Granite Bay Community Plan

Response to Comments Received Since November 2, 2011 MAC Workshop

Fencing and Screening Design from the Landscape Design Guidelines:

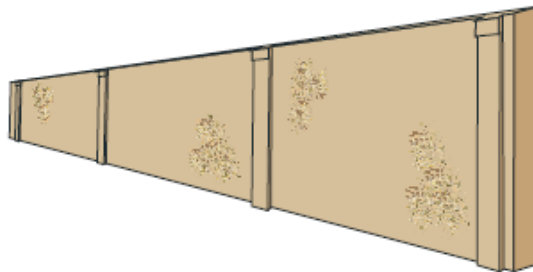
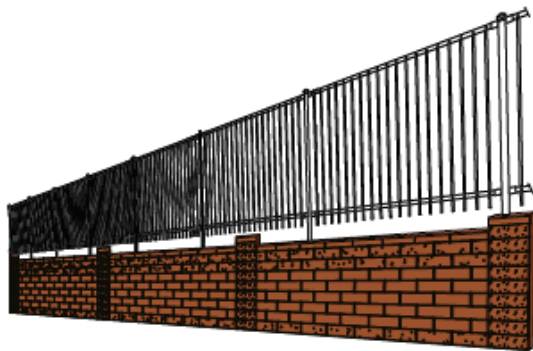
Issue: Transparent fencing reduces privacy.

Response: The gates themselves must be transparent to meet the Engineering and Surveying’s sight distance standards. Elsewhere, the Landscape Design Guidelines require new sound walls or fences 50 feet in length or longer to minimize visual monotony through changes in plane, height, material or material texture. A wall break or transparent fencing are encouraged but not required. Wrought iron fencing is considered an appropriate “transparent” fence.
